STAFF REPORT

Application for Site Plan Review SP-07-18 and Floodplain Development Review FP-02-18 Hickory Station Access Easement

DATE OF REPORT: May 4, 2018

FILES: SP-07-18 & FP-02-18

COVER SHEET

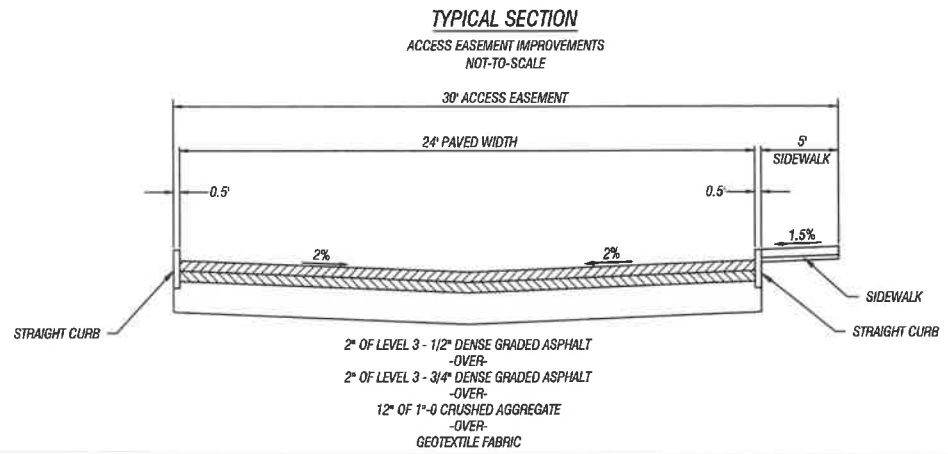
- 4.2 The applicant proposes to improve an existing private access easement with a 24-foot-wide paved accessway and five-foot wide sidewalk, with a reduction to 4.5 feet wide along the carwash building encroachment (see Attachment A, Sheet P.100), from an existing driveway fronting North Albany Road to an existing private drive to the east of the subject site.

Condition 2 **Private Access Improvements.** The extension of the shared private access shall have curb on both sides, a minimum paved width of 24 feet, and a five-foot-wide sidewalk along the north side with a reduction to 4.5 feet wide along carwash building encroachment, in accordance with the approved site plan. The sidewalk shall extend to the private shared travel aisle along the site's east boundary as shown on the approved site plan.

City Use Only	SITE PLAN - ALTERNATE
	A100A

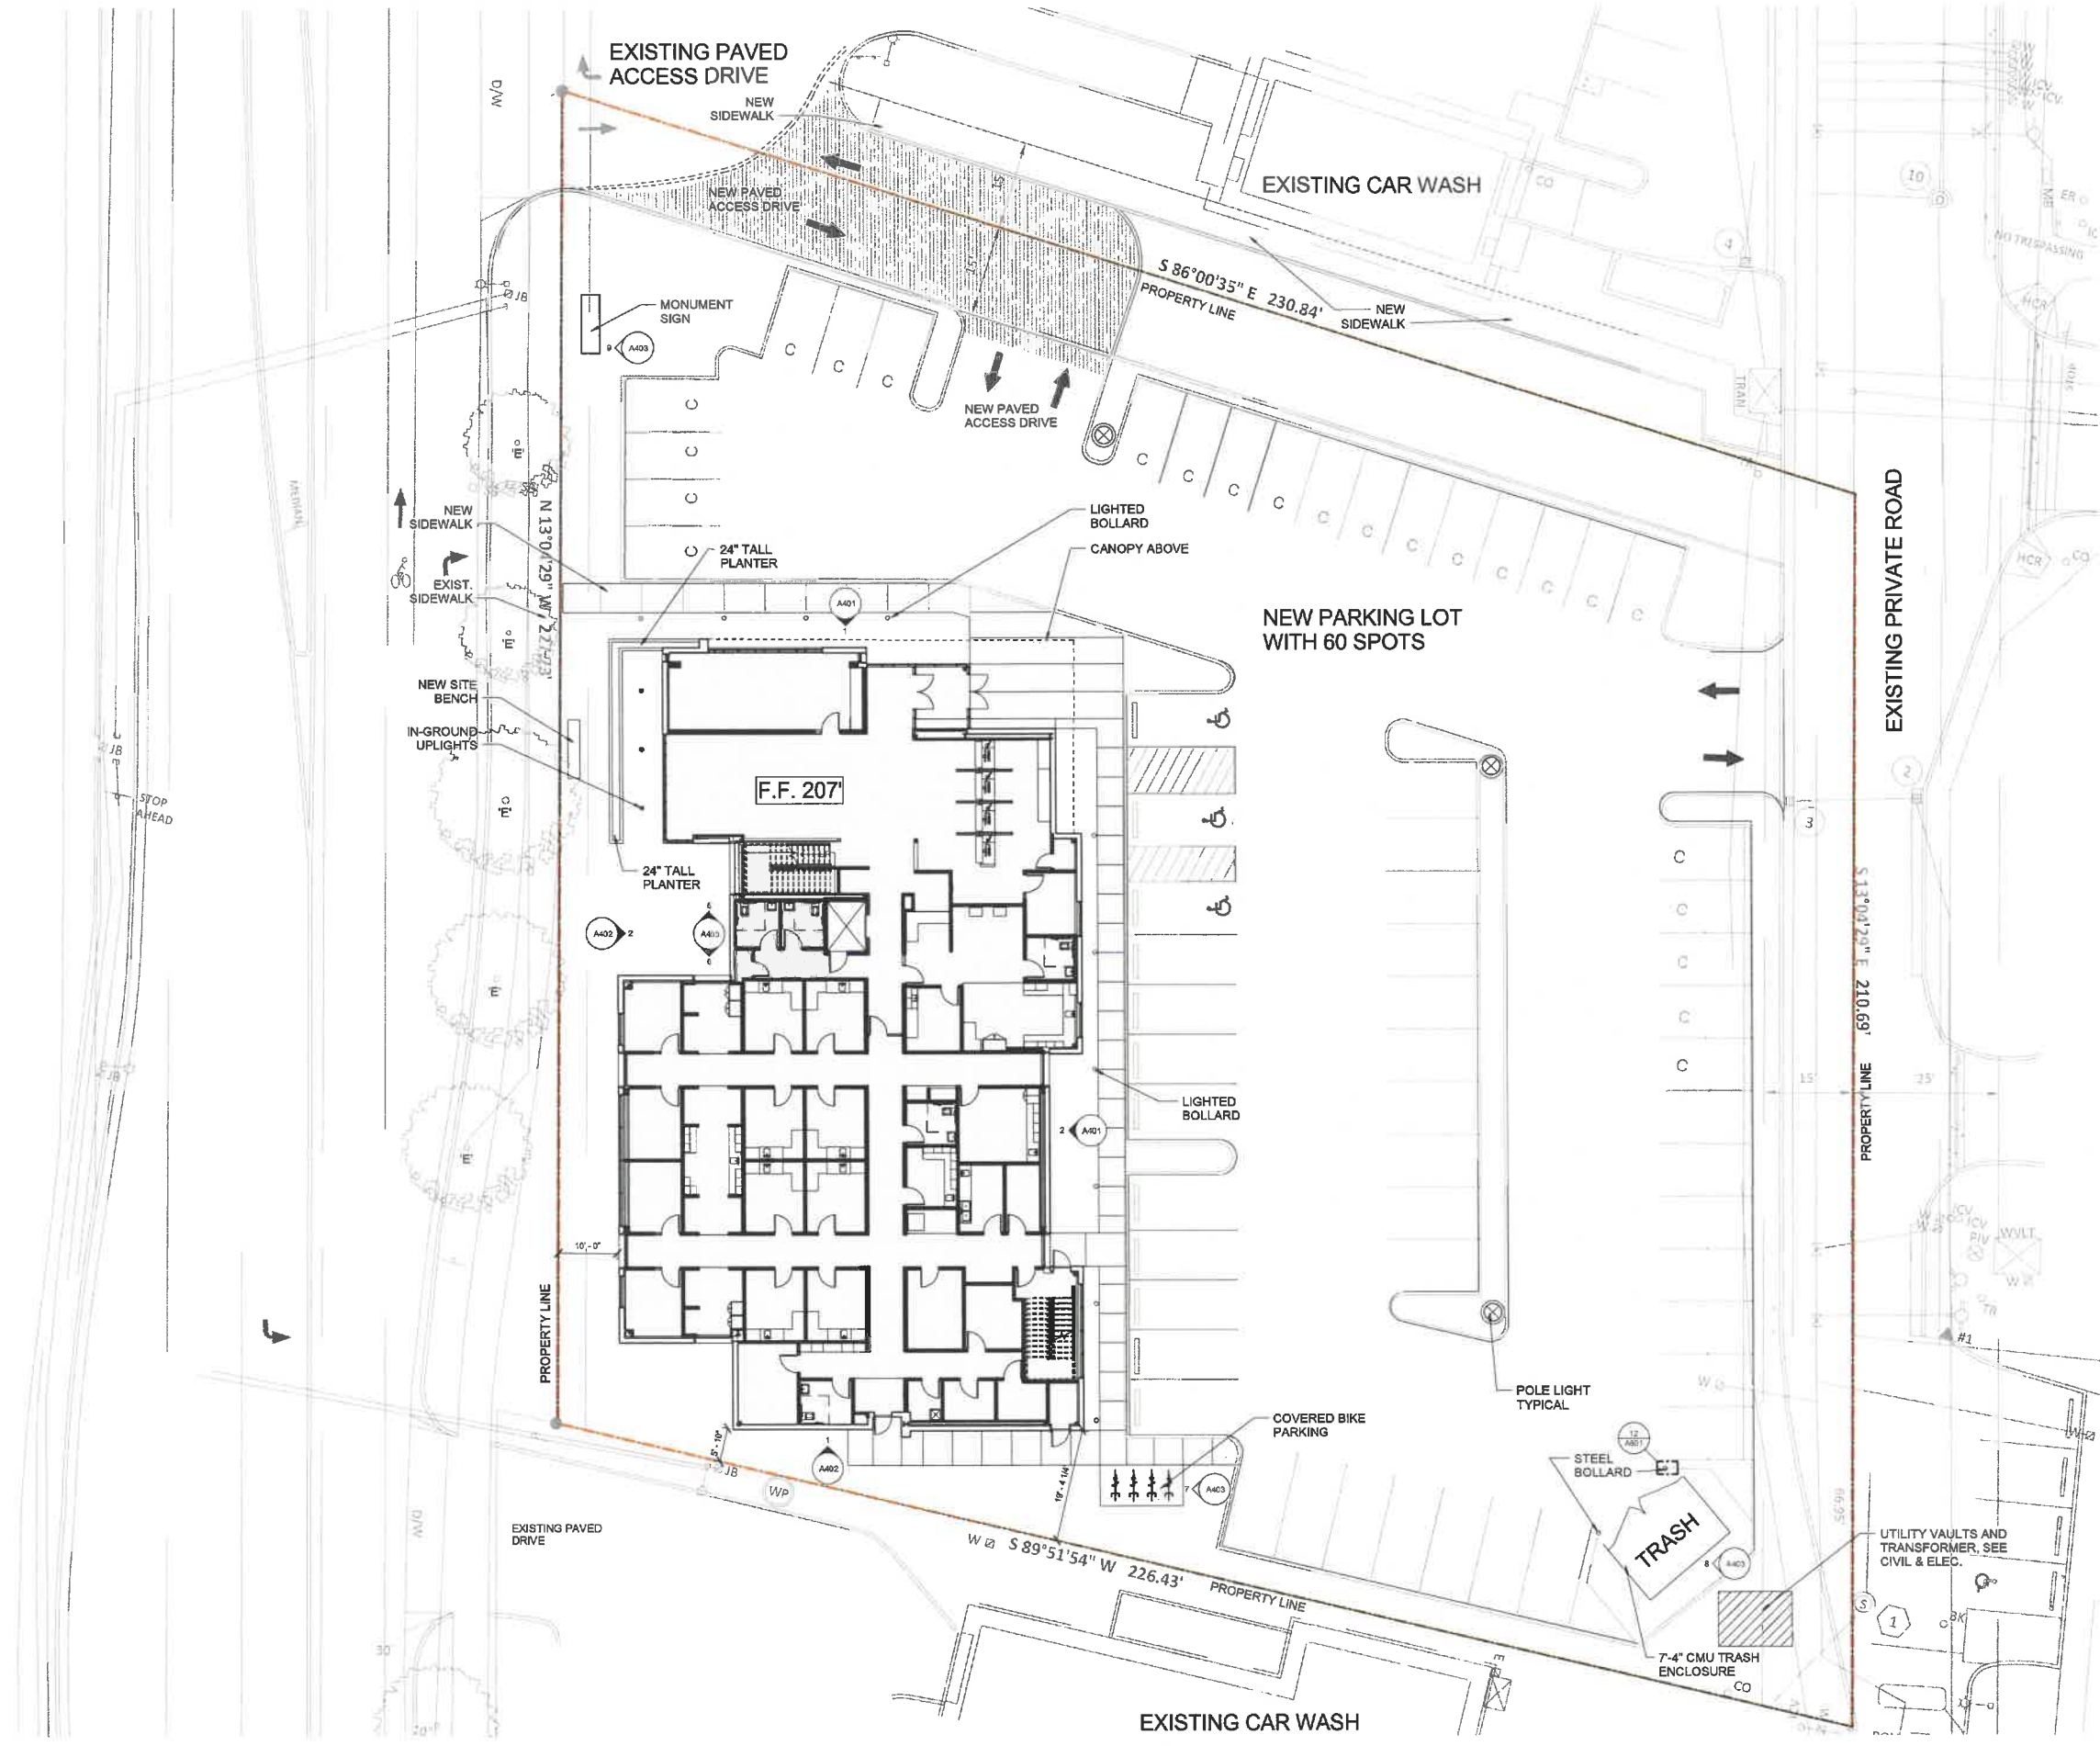
- 5.2 **Operating Characteristics.** The proposal consists of improvements to an existing private access easement along the common property line of 633 and 655 North Albany Road. The existing development at 655 North Albany Road consists of a gas station, convenience store/fast food restaurant, and self-service drive-through car wash. The existing development at 633 North Albany Road is currently under construction but will consist of a medical office building when complete. Access to both sites is via a shared driveway to North Albany Road and Hickory Street via an improved shared private access easement that runs along the east boundaries of the subject parcels. A condition of approval, regarding the medical office building (SP-18-17) includes the extension of the shared private access, including curb on both sides, a minimum paved width of 24 feet, and a five-foot wide walk along one side of the easement as shown on the approved site plan (see Attachment B, Sheet A100A).

STORM SEWER &
GRADING PLAN

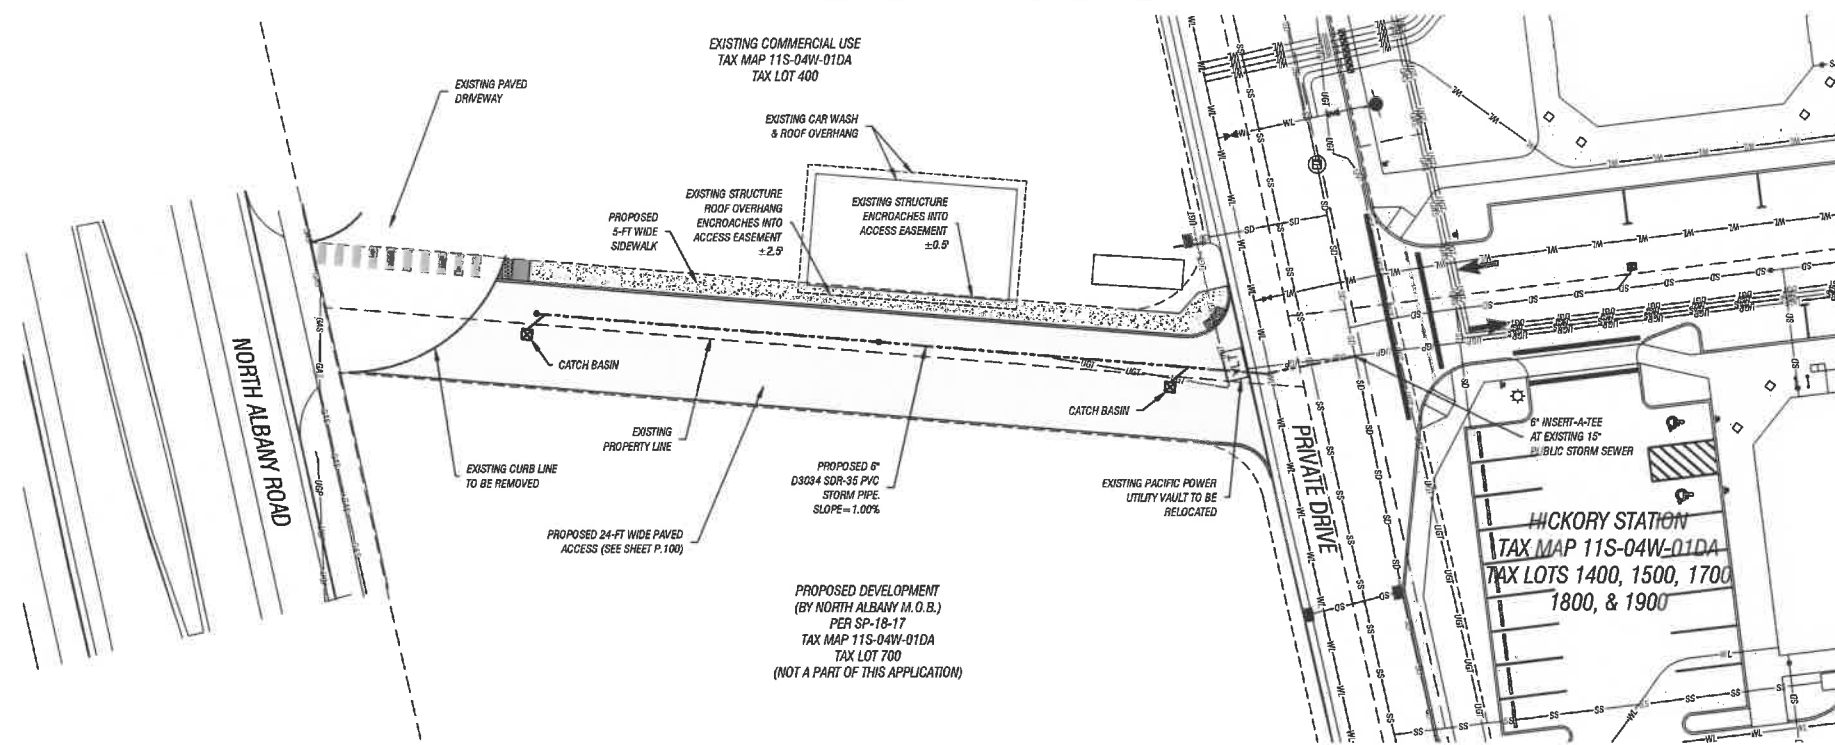
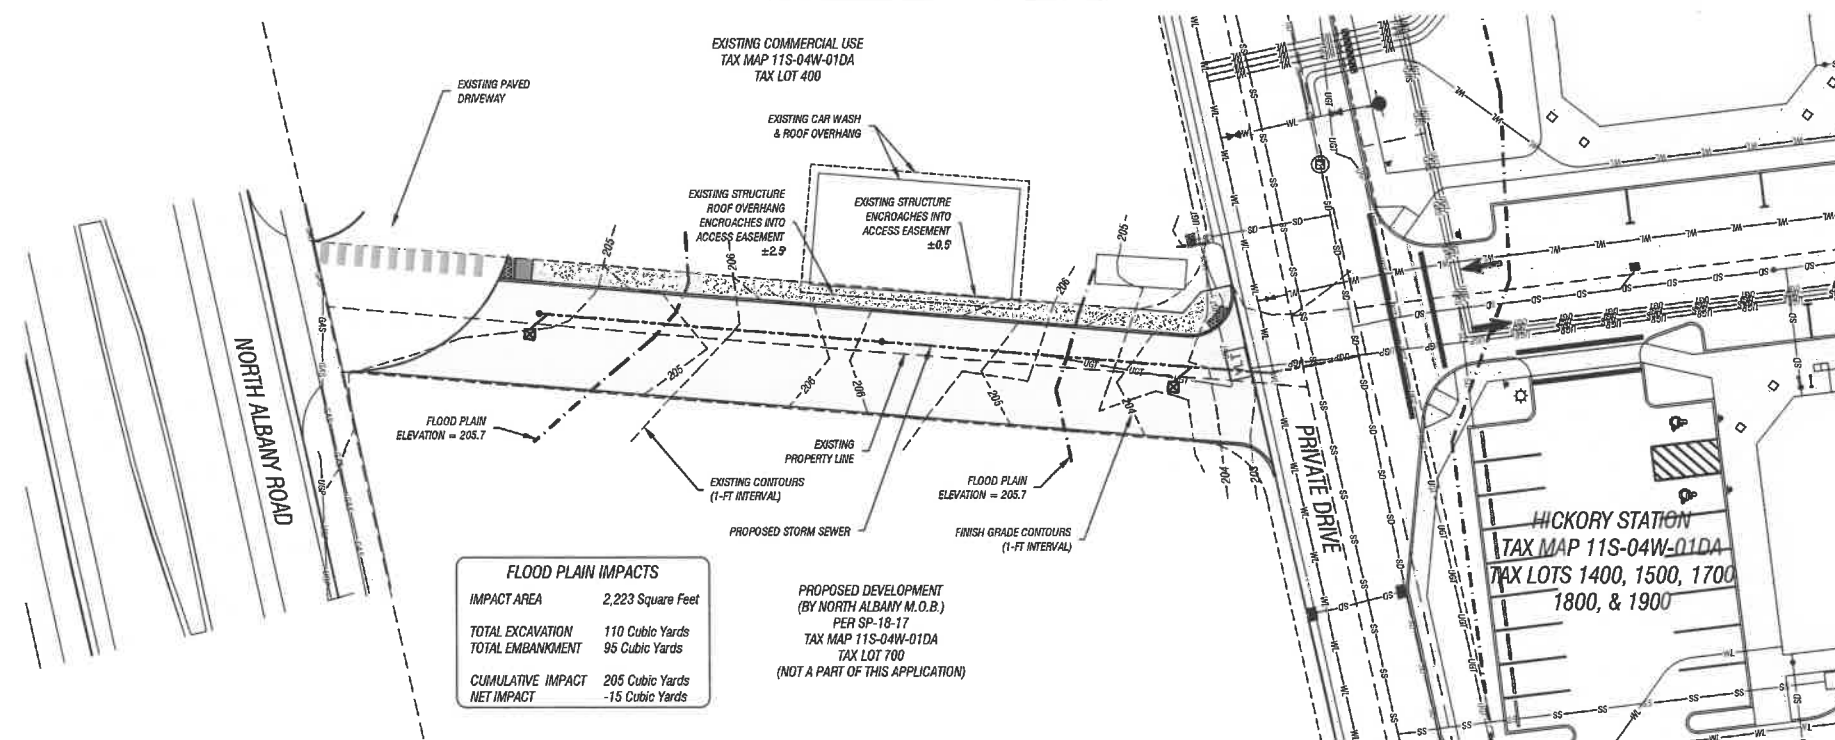
- 1.3 As shown on the storm sewer and grading plan (Attachment D, Sheet P.101), the proposed access easement easements include a 24-foot wide paved accessway and five-foot wide sidewalk, with a reduction to 4.5-feet along carwash building encroachment.

- 2.1 The applicant states that “the existing Pacific Power utility vault will be relocated” (Attachment D, Sheet P.101).
- 2.2 The proposed private storm water collection system is evaluated under Site Plan Review Criterion One (above); those findings and conclusions are included here by reference.
- 2.3 No other utilities are located within the site area.
- 2.4 Utilities located within the subject site have been designed to minimize flood damage.
- 2.5 This criterion is met without conditions.

- 7.1 The proposed grading plan (Attachment D, Sheet P.101).) shows the location of the 100-year flood contour line with a BFE of 205.7 feet (NAVD '88). The floodplain boundary and BFE is based on FIRM Panel #41043C0213H, dated December 8, 2016.
- 7.3 As this development is not a land division, and this site plan review is not required to be recorded.
- 7.4 This criterion is met without conditions.

- 1.1 The proposed access easement improvements consist of a paved drive and pedestrian sidewalk partially within the 100-year flood plain as shown (Attachment D, Sheet P.101).
- 1.2 There are no watercourses located within the boundaries of the subject property.
- 1.3 The proposed finished grade of the subject access easement improvements will only change slightly and will ultimately increase the available flood storage area within the flood plain by 15 cubic yards.
